AMENDMENTS TO THE DRAWINGS:

FIG.2

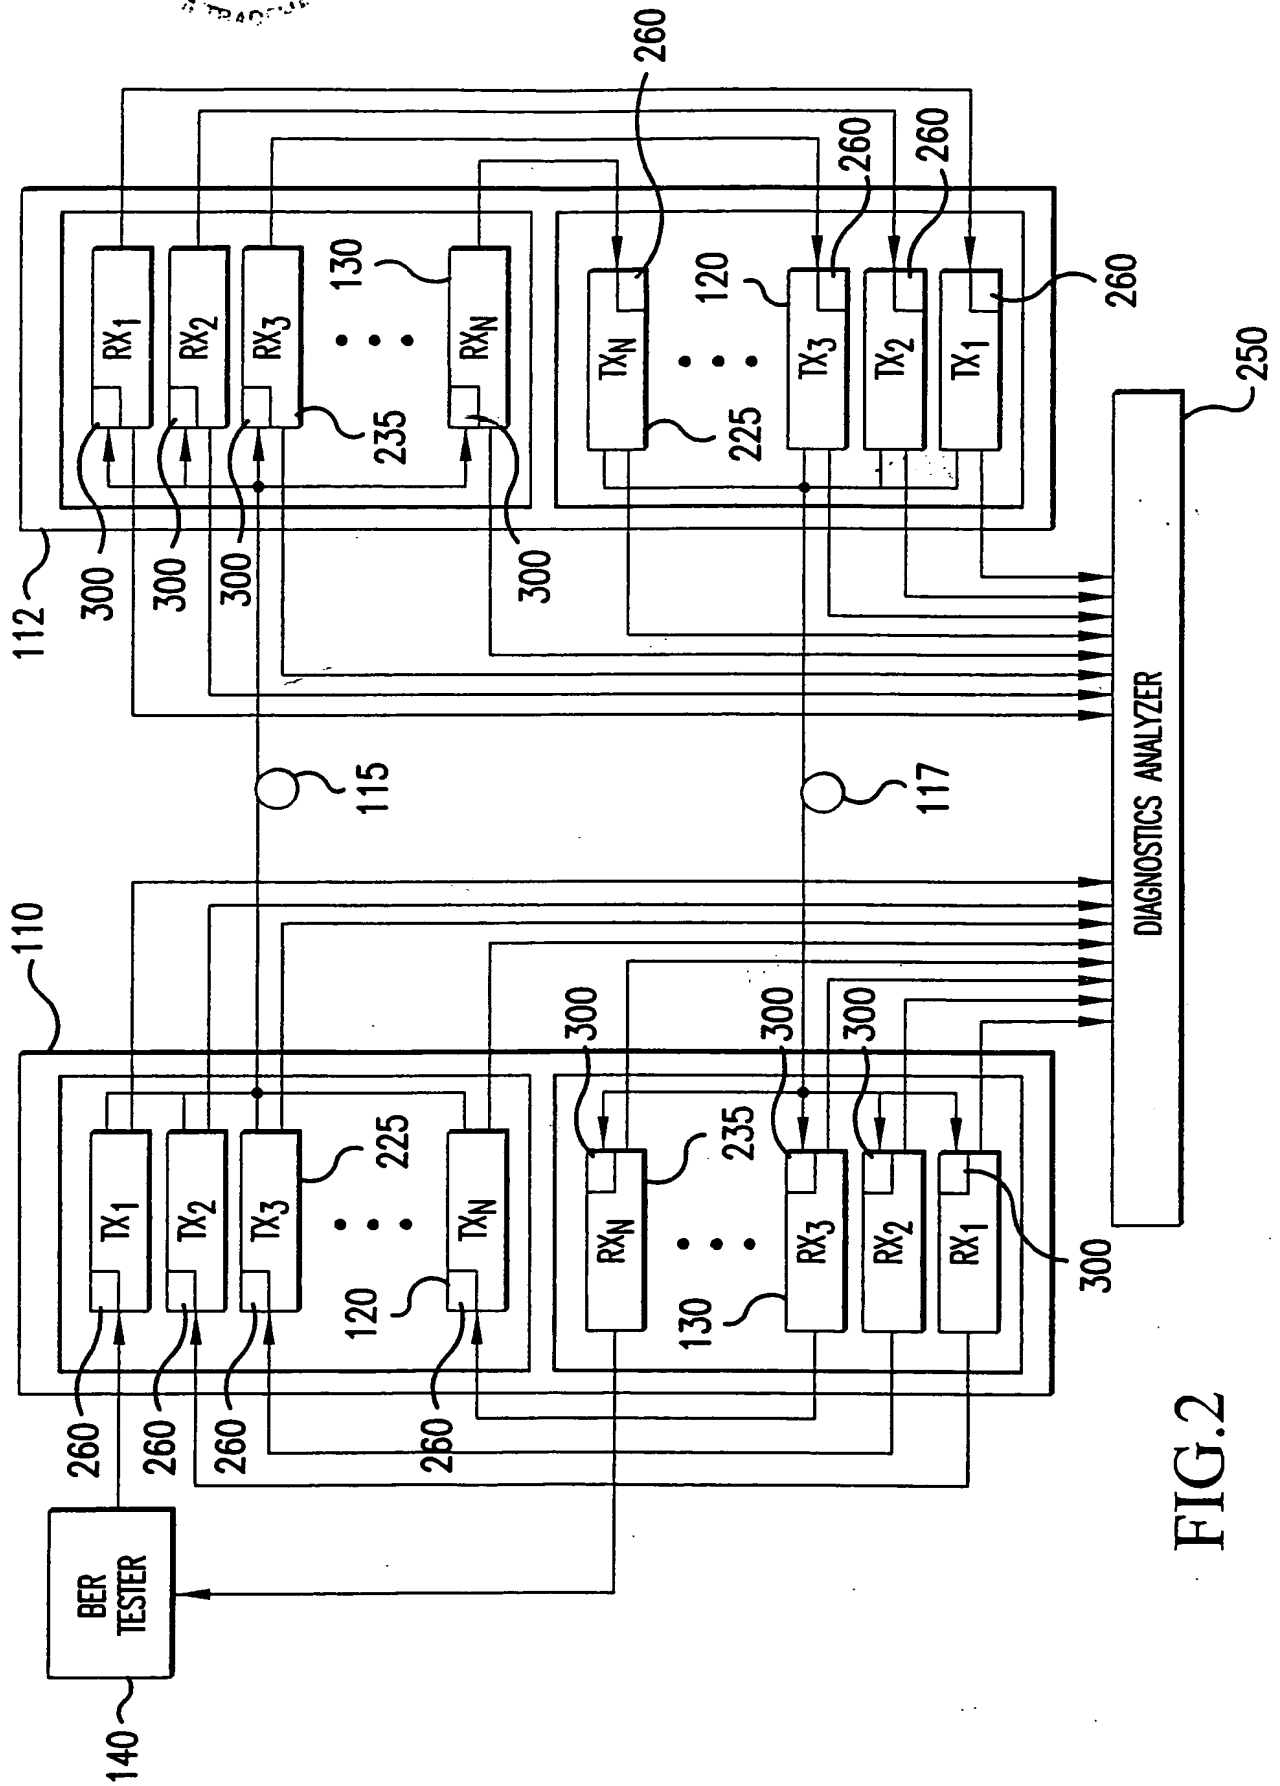
The attached sheet of drawing includes changes to Fig. 2. This sheet, which includes Fig. 2, replaces the original sheet including Fig. 2. In Fig. 2, the location of the box 300 in element RX_N has been moved to the upper left corner.
